## Development Permit Panel

Wednesday, June 15, 2016  
3:30 p.m.

1. **Development Permit 14-662341**  
(REDMS No. 4984962)

APPLICANT: Hollybridge Limited Partnership (Intracorp)  
PROPERTY LOCATION: 6900 Pearson Way

Plan 10e

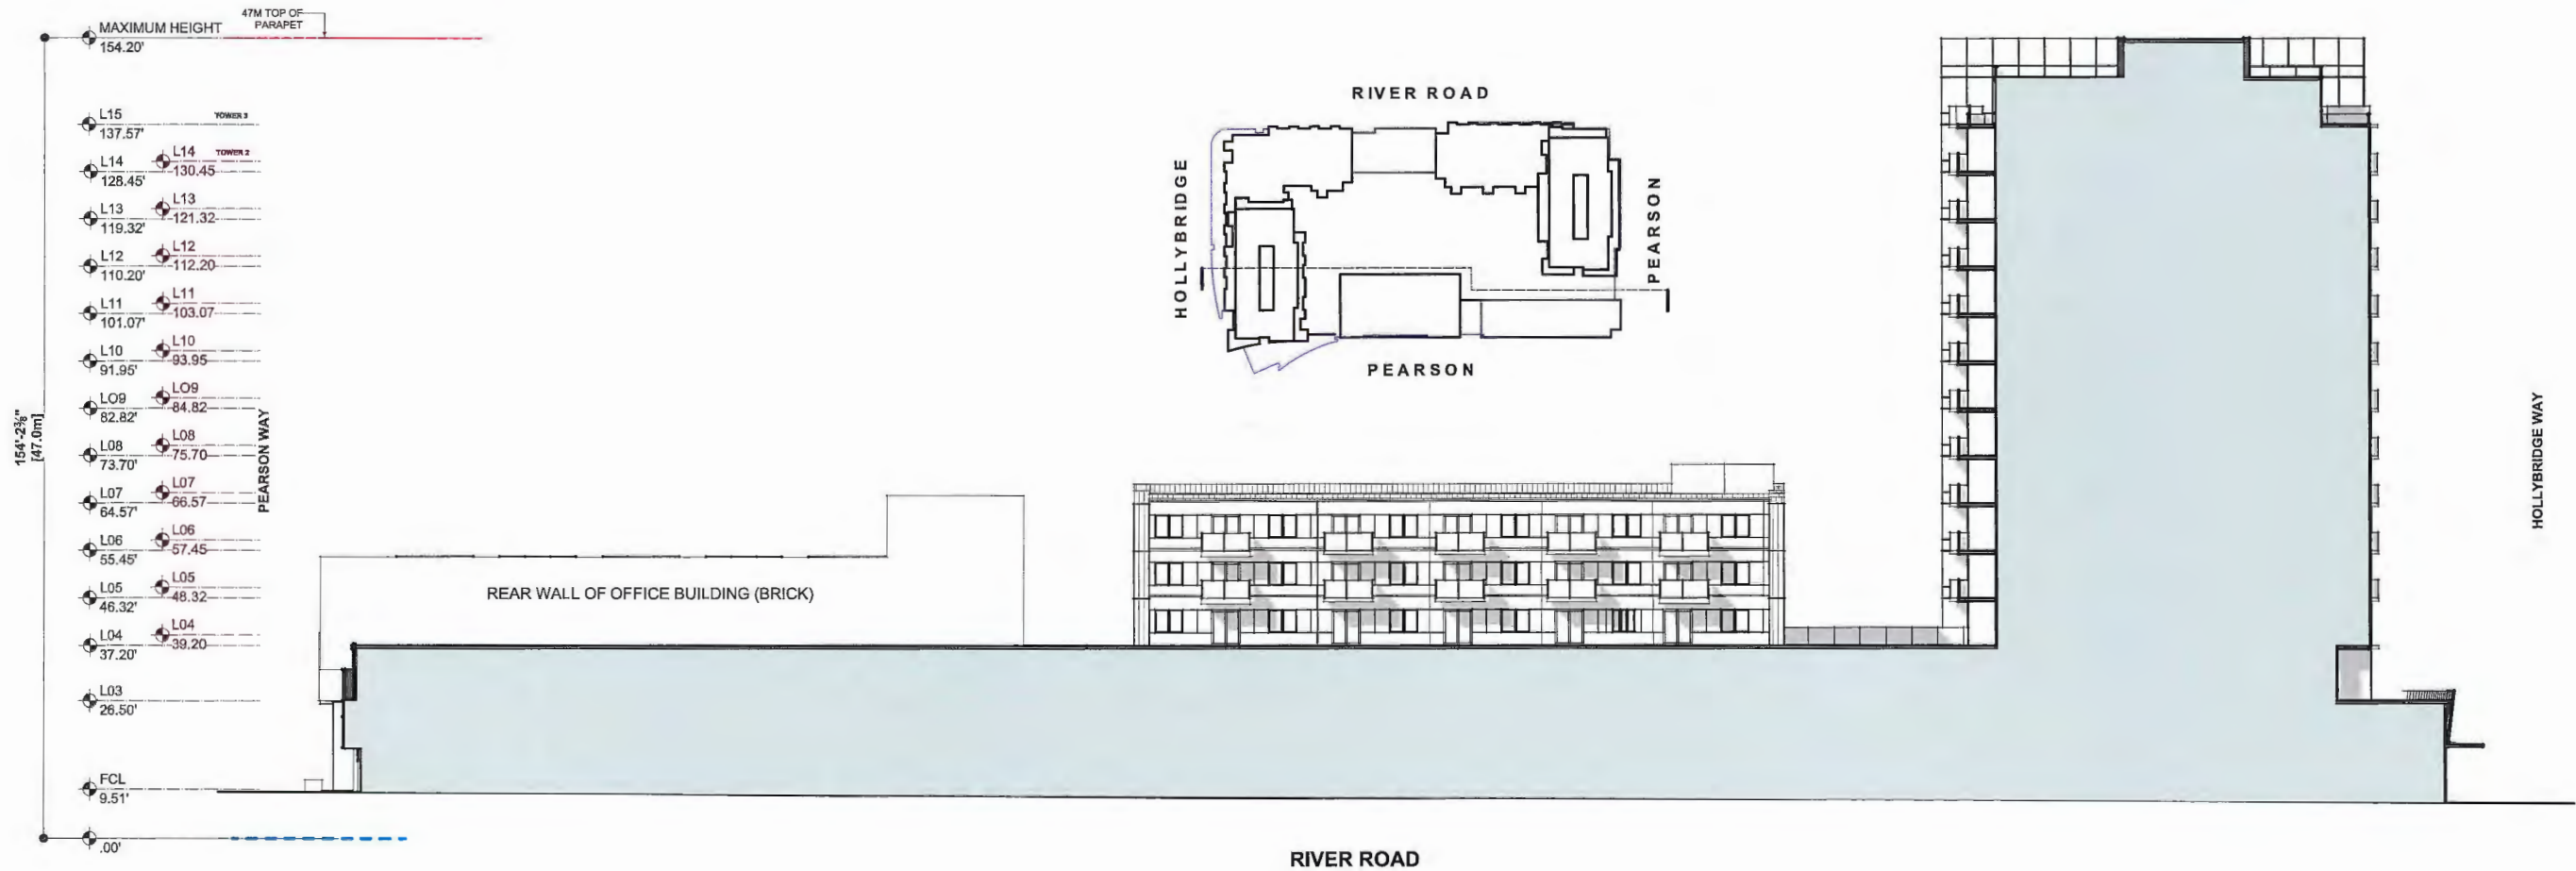
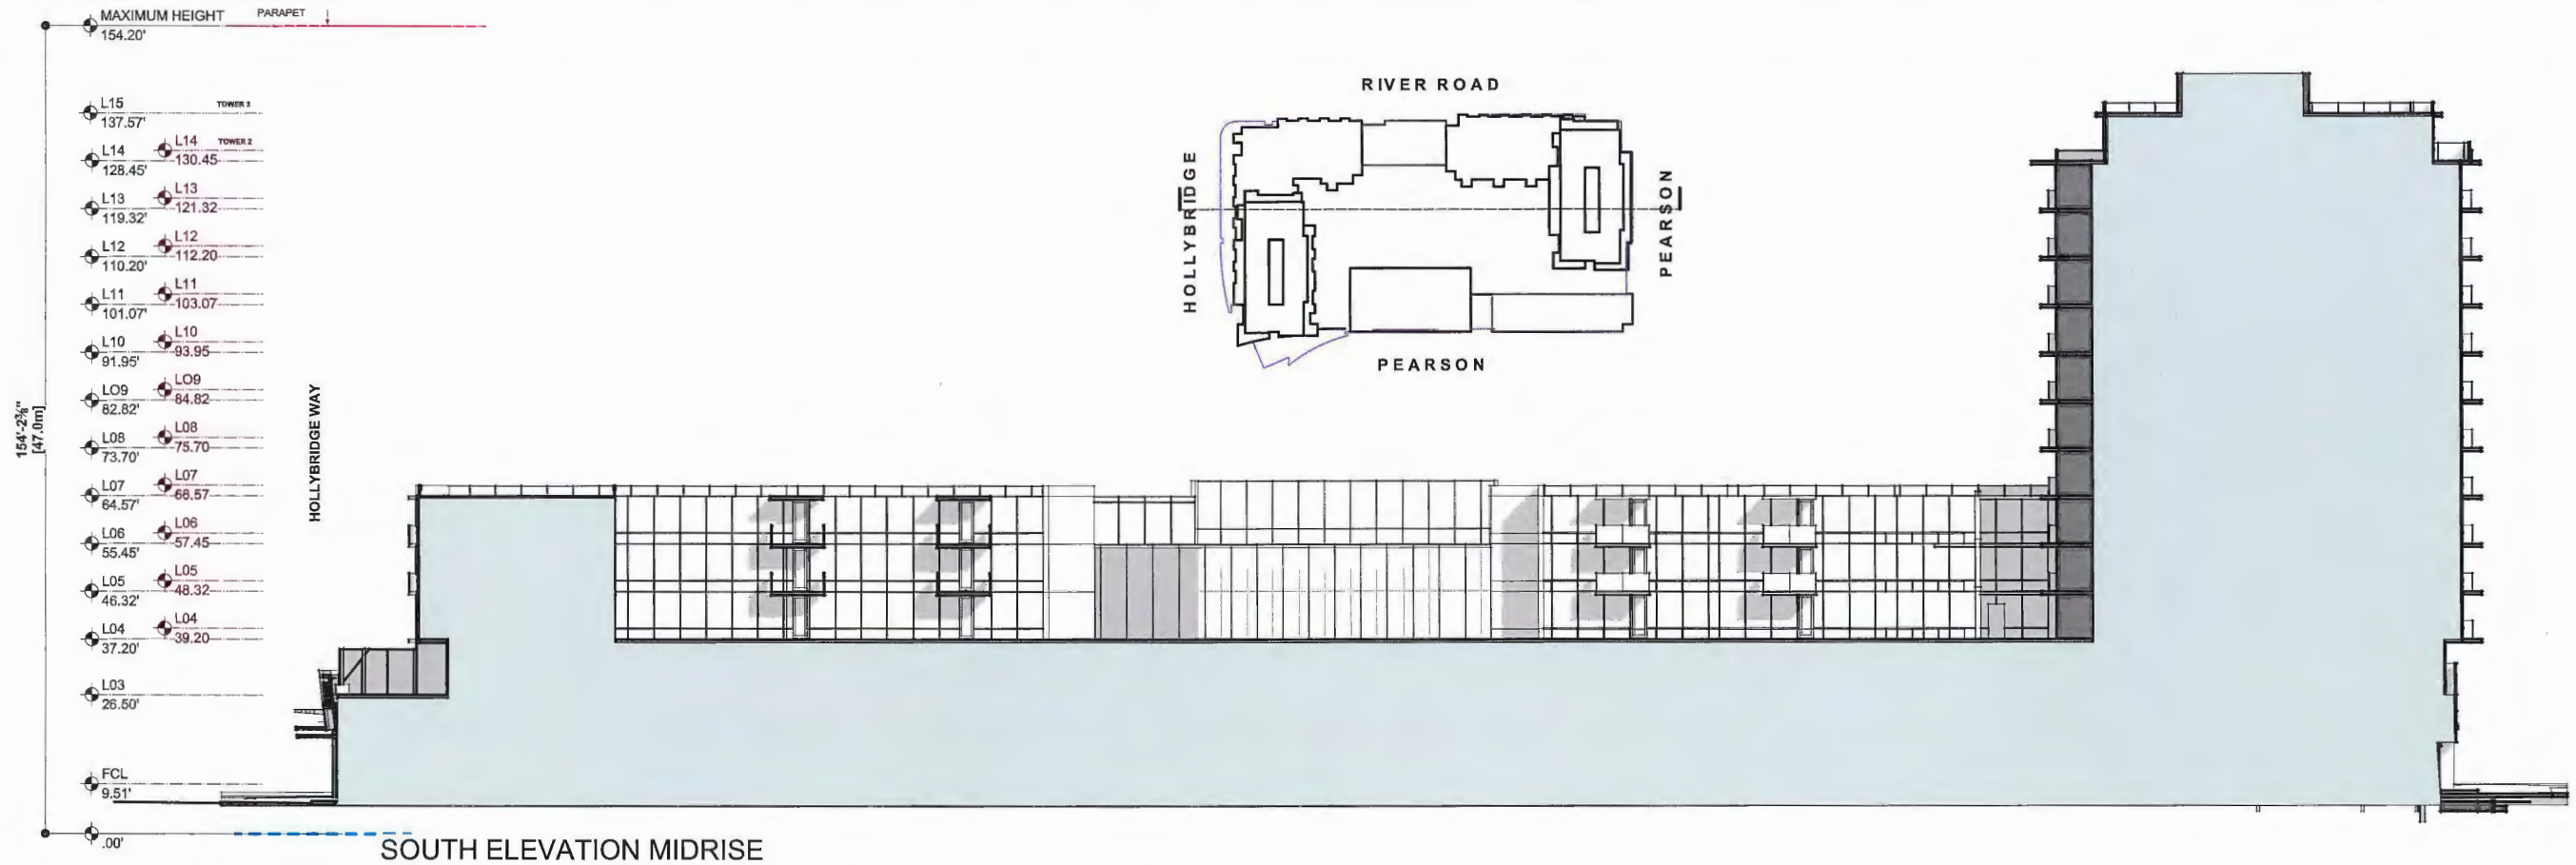
- like the variety of different architectural styles; appreciate the idea of extended planes; however, it could be further extended throughout the proposed development to tie together the different architectural styles; consider extended planes of materials other than glass, e.g. concrete, brick, etc.; proposed pillar does not appear to work with the idea of extended planes; consider design development;

- the west tower's curved wall does not appear dynamic in the model; consider applying the idea of extended plane to the curved wall or other measures to make it more exciting;

**DEVELOPER RESPONSE:** *The use of extended planes has been further refined throughout.*

**DEVELOPER RESPONSE:** *The design of the curved wall has been refined.*
